### PLANNING DEPARTMENT

#### **PLANNED UNIT DEVELOPMENT PERMIT NO. 05-000005 (PUD 05-000005)**

**Project:** "Royal Ali'i" – a 19-lot subdivision

**Location:** TMK: 7-7-004: 057 & 058; Kaumalumalu, North Kona, Hawai'i

Figure 1: Master Plan Concept

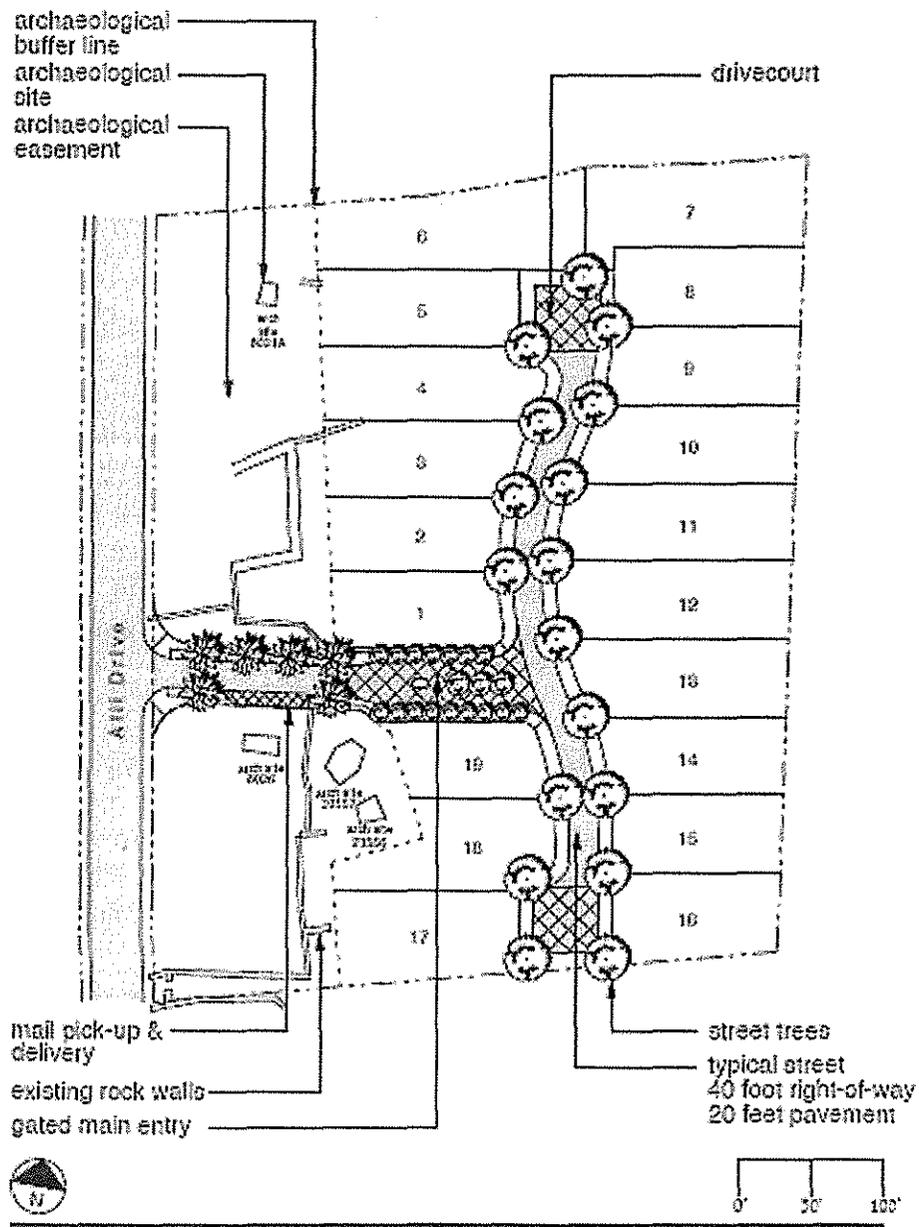
3. Master Plan and Street Layout. The proposed Planned Unit Development shall be developed in a manner as substantially represented within exhibits attached to this Planned Unit Development Permit. An exception is the extension of the interior subdivision roadway to the northern boundary of the Property in order to facilitate its future connection with future roadways should the adjoining property be developed.

Figure 13: Street Character

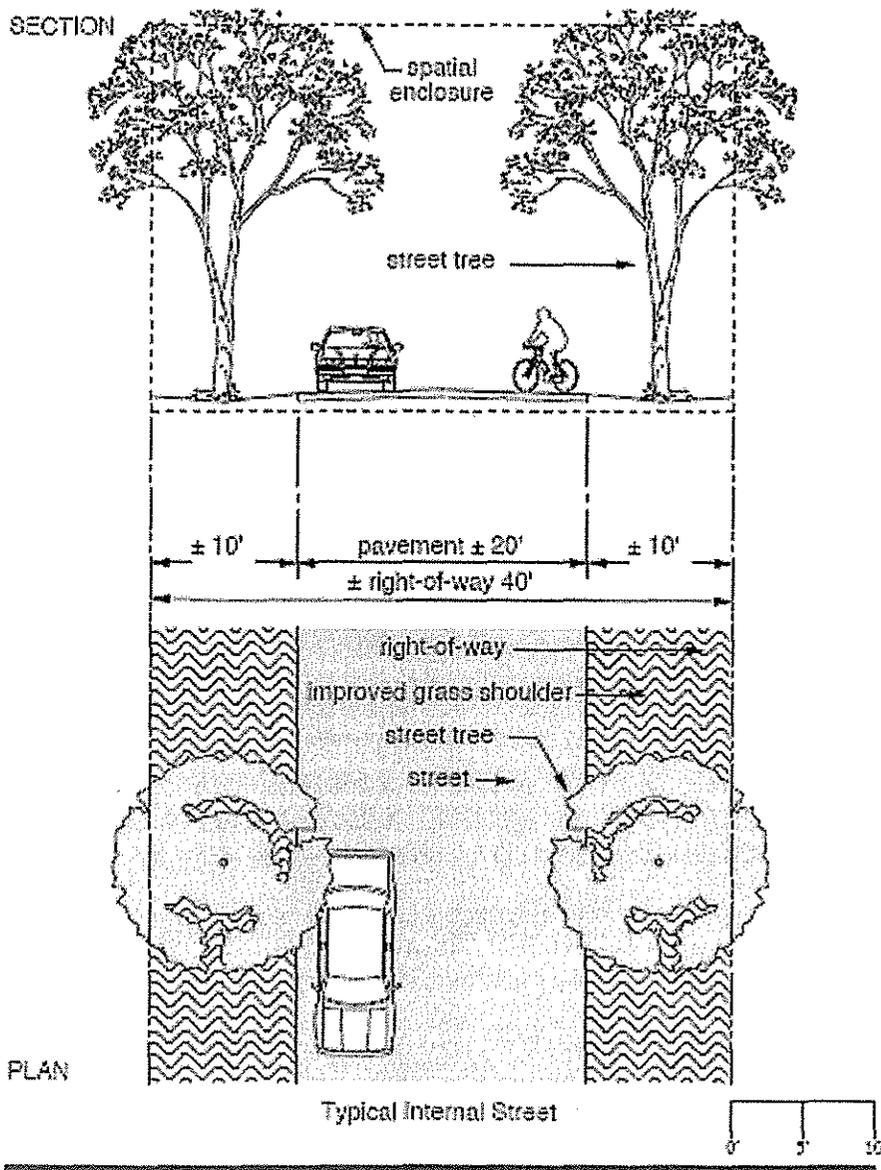
- **Minor Interior Subdivision Streets (40-foot wide road right-of-way with 20-foot wide pavement with 10-foot wide grassed shoulders-Figure 13)**. We approve of the Applicant's request to install a 10-foot wide landscaped median at the subdivision entrance with 15-foot wide travel lanes and 9-foot wide grassed shoulders within a 58-foot wide access easement. The location of the median must meet with the approval of the Department of Public Works to ensure that its location does not inhibit larger vehicles like buses or fire trucks.

Figure 14: Street Character

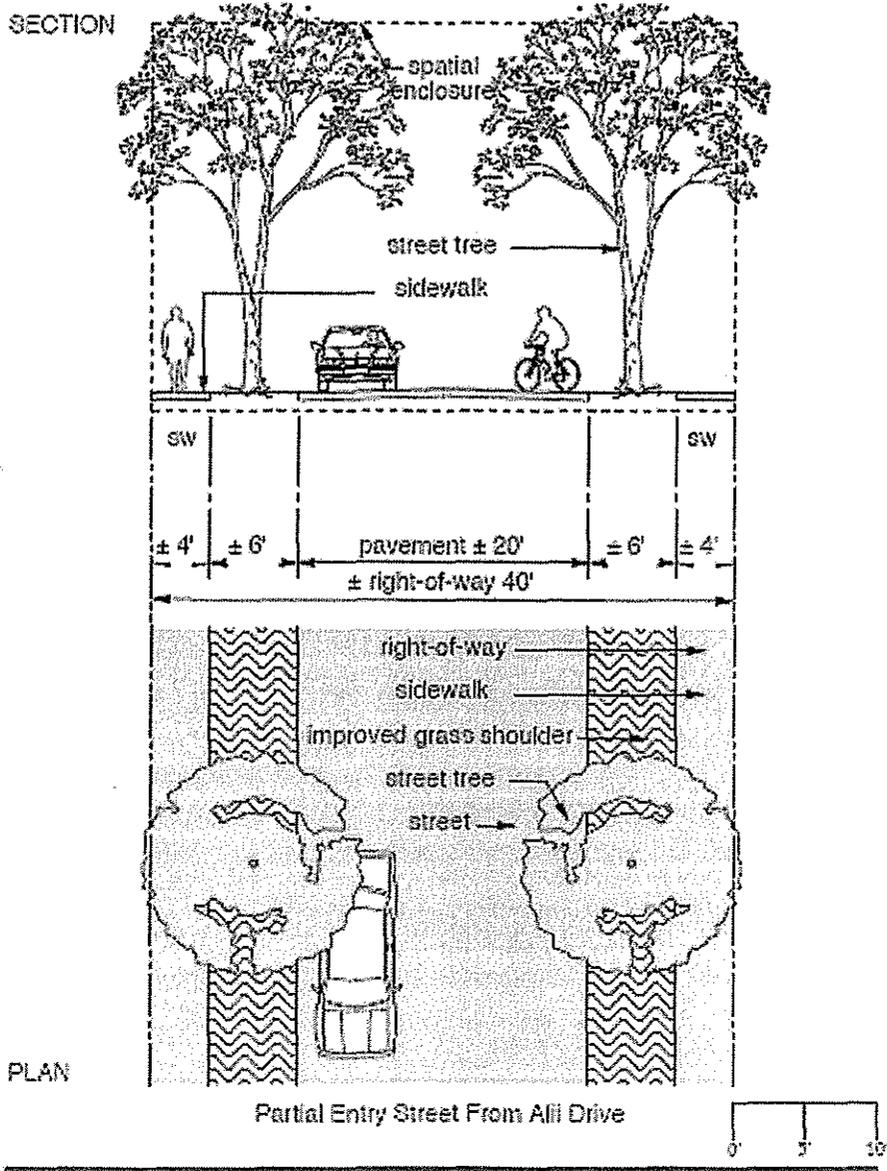
- **Minor Entry Street from Ali'i Drive (40' wide road right-of-way in lieu of 50' ROW with alternative shoulder improvements-Figure 14)**. The proposed standards for the 40-foot wide minor street-type roadway will deviate from the minimum 50-foot wide ROW and shoulder improvements specified by DPW Standard Details R-33 and R-34. The Applicant is proposing a standard pavement width of 20 feet with 6-foot wide grassed shoulders and 4-foot wide sidewalks on each side. The lower volume and speed of vehicles typically carried by these minor streets affords the opportunity to reduce the pavement width and manage speeds. The proposed 20-foot wide pavement, which does meet County standards, will provide opportunities for a landscaped shoulder/drainage swale while still accommodating two-way traffic.

Figure 15: Drivecourt

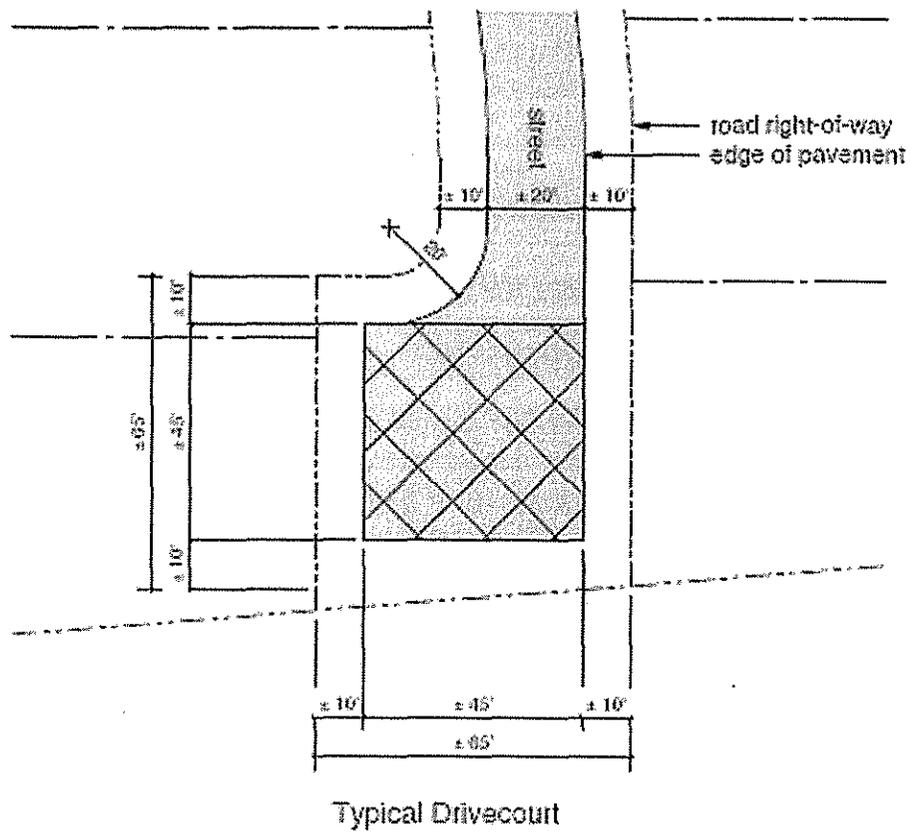
- **Cul-de-sacs** (Hawaii County Code §23-48). The Applicant is requesting the use of a 45-foot wide square drivecourt at the end of cul-de-sacs in lieu of the typical circular turnaround with a 45-foot radius. Since Section 23-48(b) gives the Planning Director the discretion to allow a T-turnaround or other suitable turnaround, this PUD hereby makes such determination that the proposed drivecourt is acceptable as proposed in Figure 15 since the dimensions meet the turning radius requirements of a fire truck.

Figure 18: Special Paving

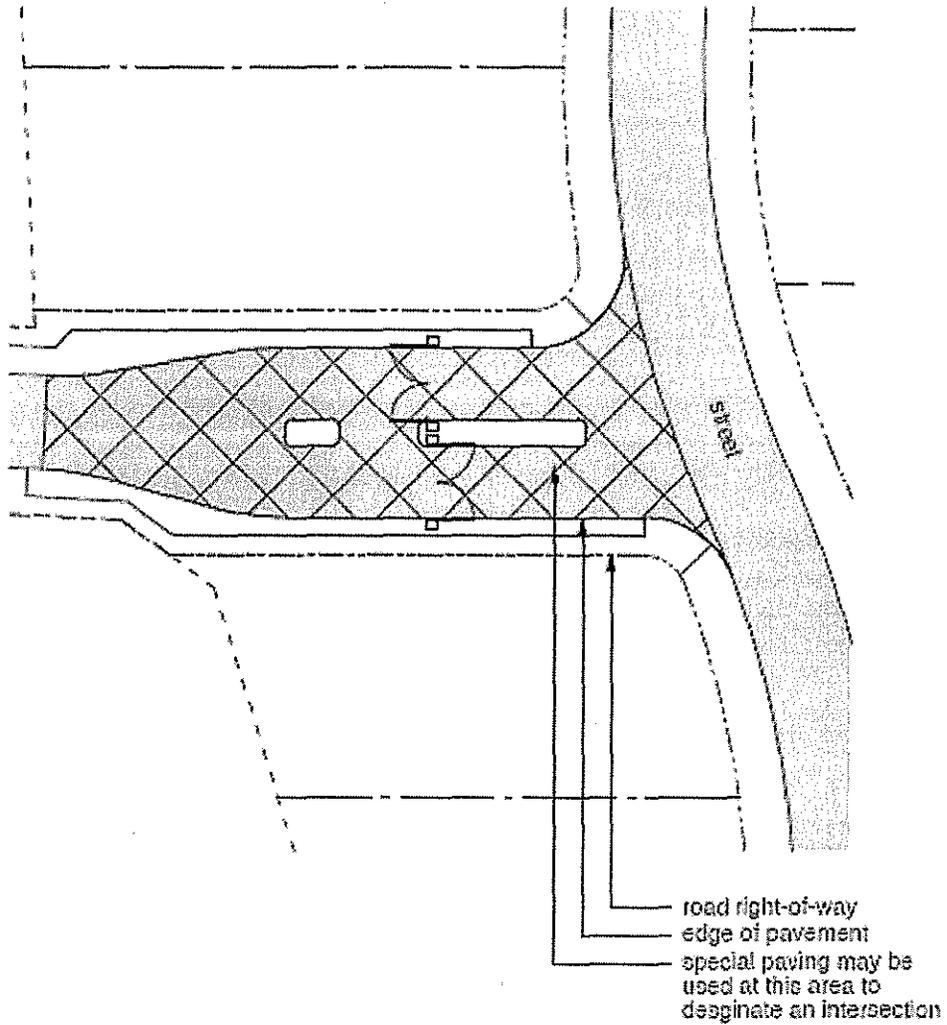
- **Landscaped Median (52-foot wide roadway right-of-way with 15-foot wide travel lanes and 9-foot wide grassed shoulders-Figure 18)**. We approve of the Applicant's request to install a 6-foot wide landscaped median along the subdivision entry street with 15-foot wide separated travel lanes and 6-foot wide grassed shoulders and 4-foot wide sidewalks within a 52-foot wide right-of-way. The location of the median must meet with the approval of the Department of Public Works to ensure that its location does not inhibit larger vehicles like buses or fire trucks.
